RE: **Grants Reclamation Project – DP-200 Renewal – Response to September 12, 2000 NMED Letter Transmitting Comments / Questions on Renewal Application**

**HOMESTAKE MINING COMPANY
Grants Reclamation Project
DP-200 Renewal**

**RESPONSES TO
NEW MEXICO ENVIRONMENT DEPARTMENT
REGARDING QUESTIONS / COMMENTS ON DP-200
RENEWAL APPLICATION
PER
NMED LETTER DATED SEPTEMBER 12, 2000**

FIGURE 40. MOLYBDENUM CONCENTRATIONS FOR WELLS D1, X, S4, F, FB AND GH.

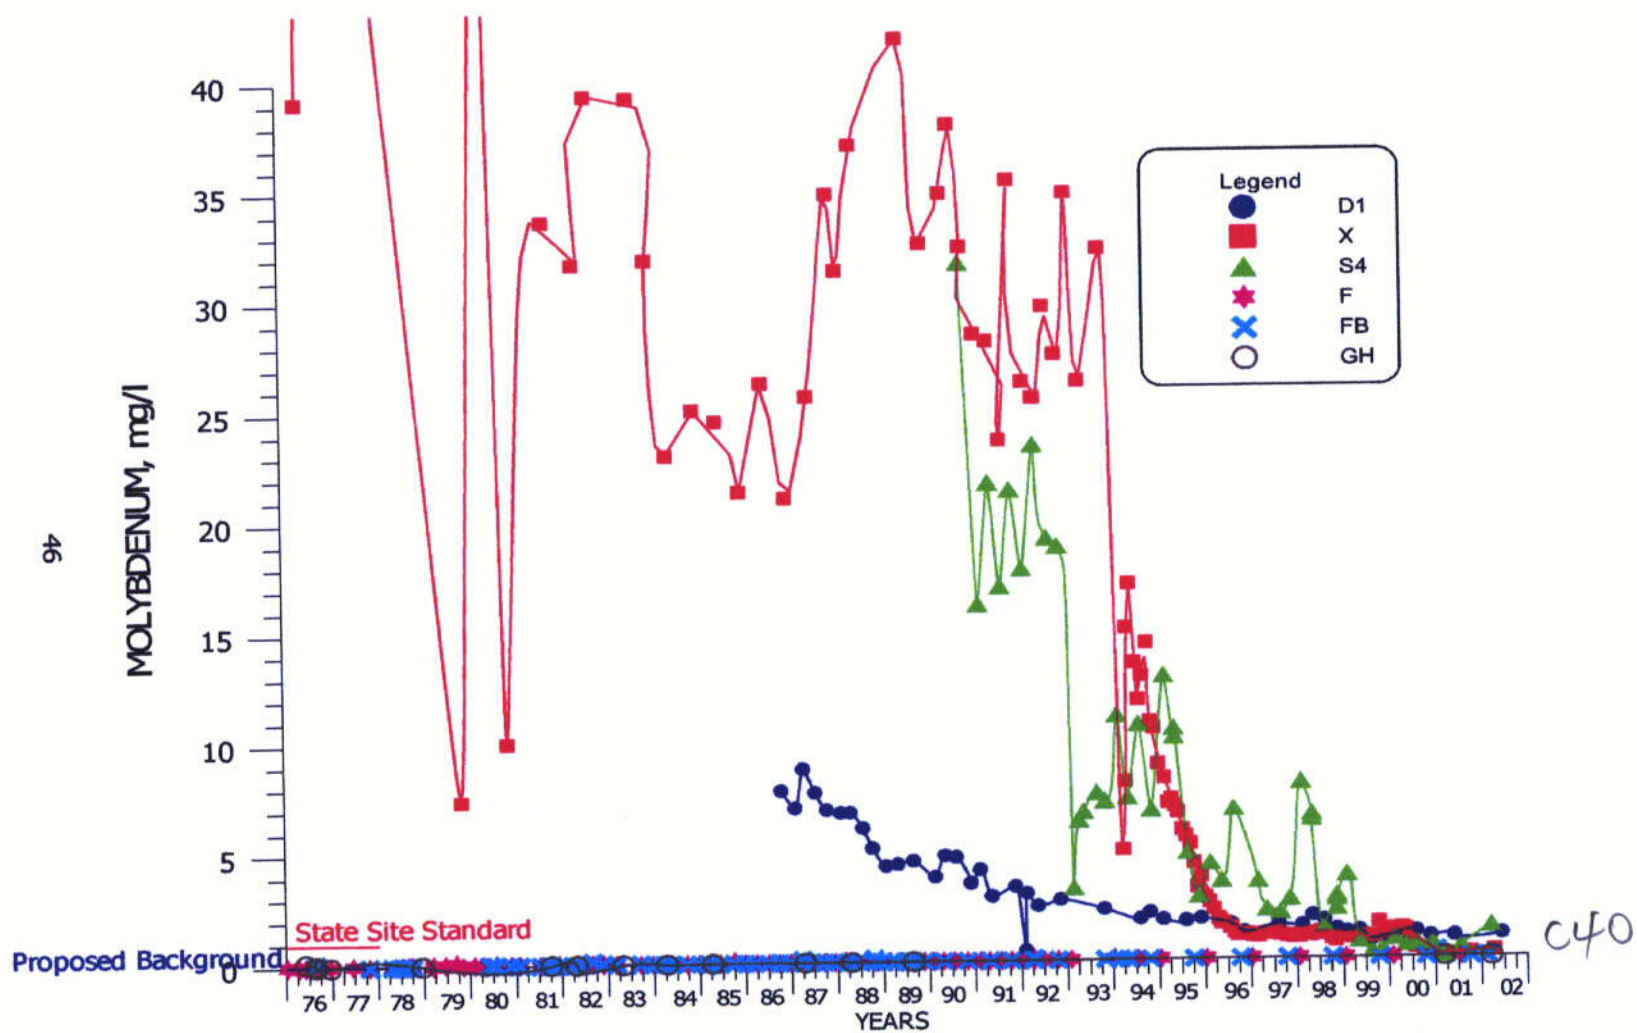
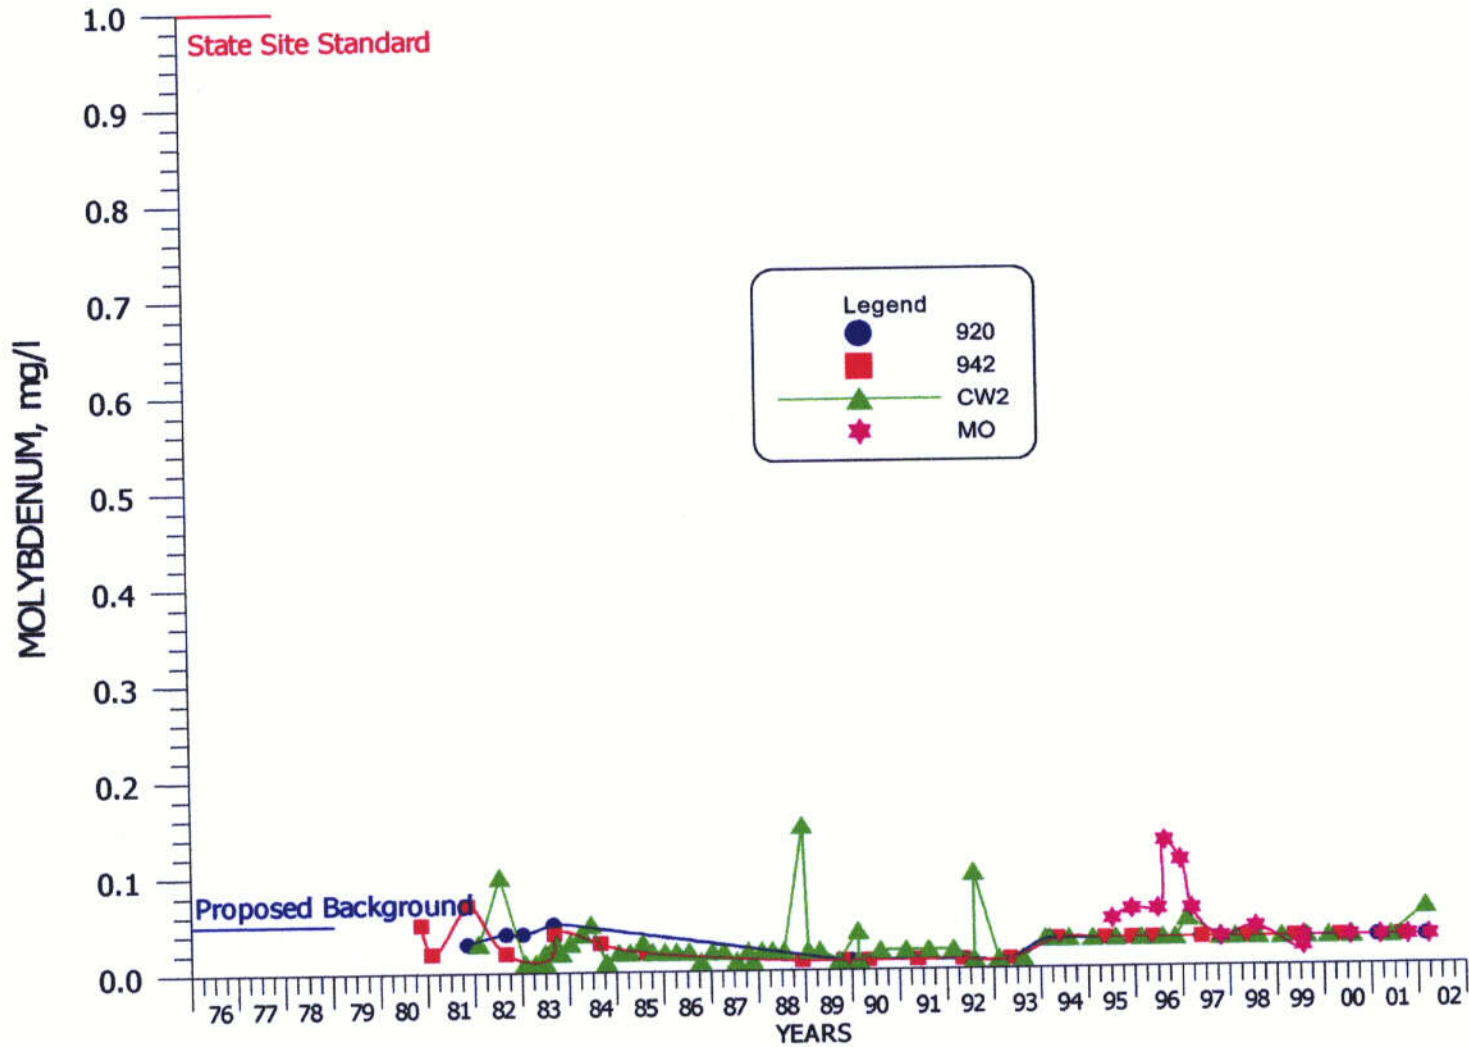
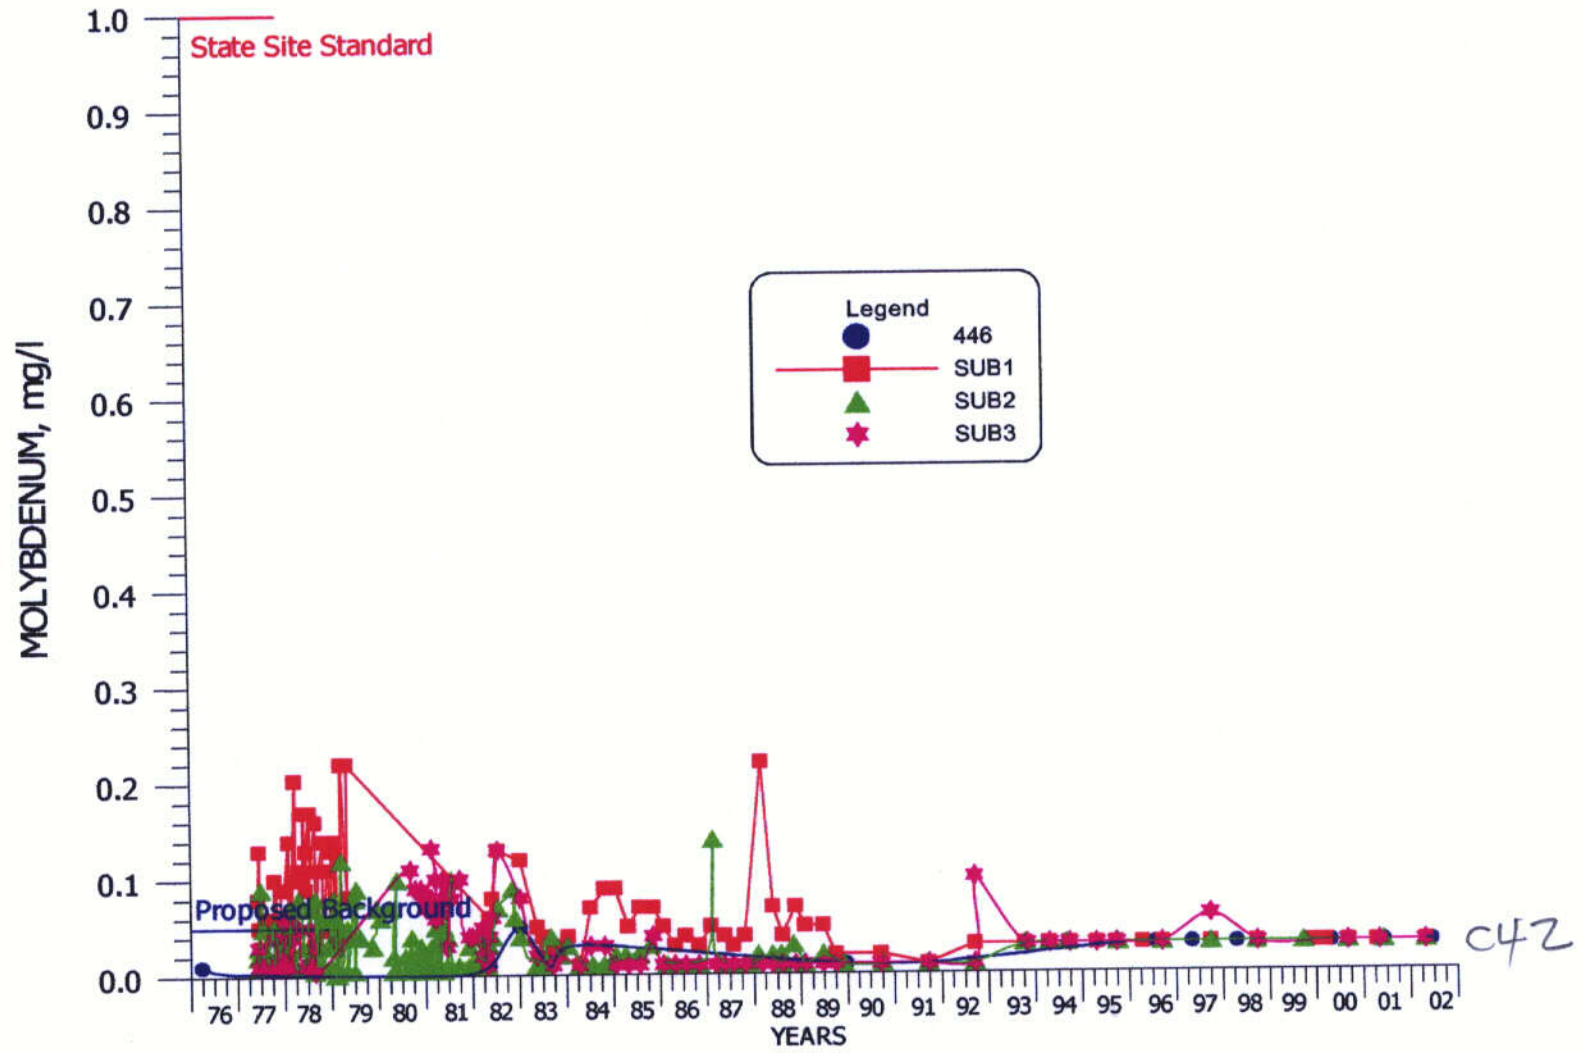
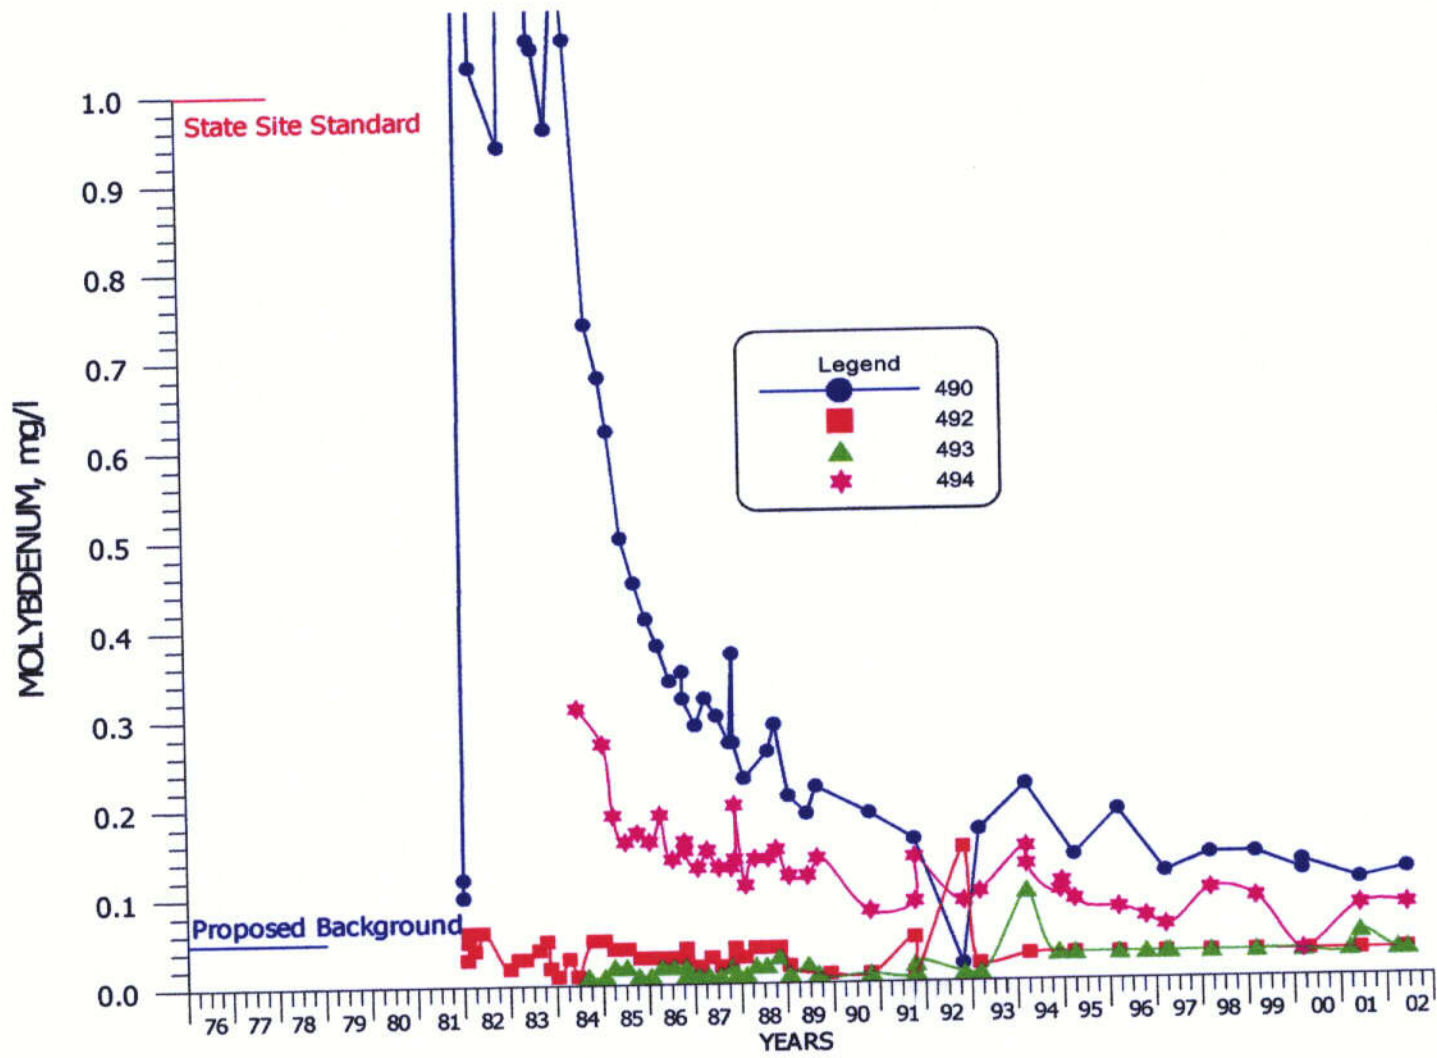
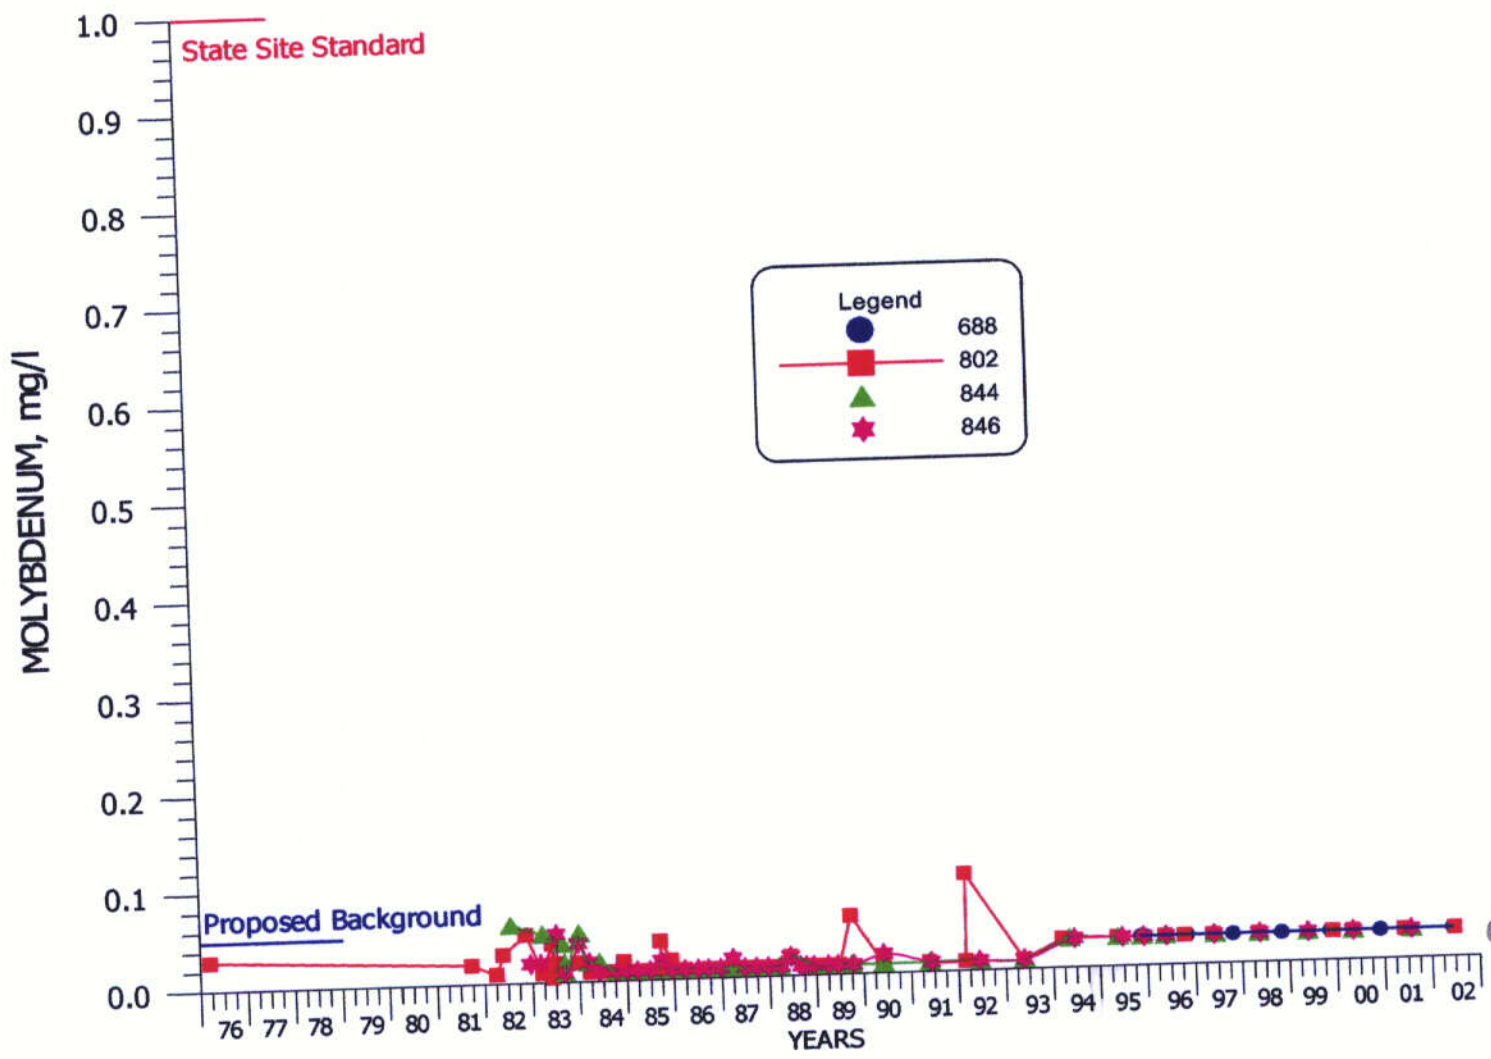
Comment: III.1.B. Graphs of Water-quality Data for the Table 2 Wells

Response: Plots for the routine monitoring wells from Table 2 of the NRC license are presented for sulfate, TDS, chloride, uranium, selenium, molybdenum and nitrate concentrations as Figures 15 through 49. The first group of wells for each of these constituents are presented for the three POC wells (Wells D1, X and S4) and

the initial figure also includes on site wells (Wells F, FB and GH). The following tabulation lists the figure numbers for each of the constituents:

CONSTITUENT	FIGURE NUMBER
SO4	15 – 19
TDS	20 – 24
Cl	25 – 29
U	30 – 34
Se	35 – 39
Mo	40 – 44
NO3	45 – 49

A few different vertical scales were required due to the large variations in parameter concentrations. The present State standard and the proposed background concentrations are presented on the plots.
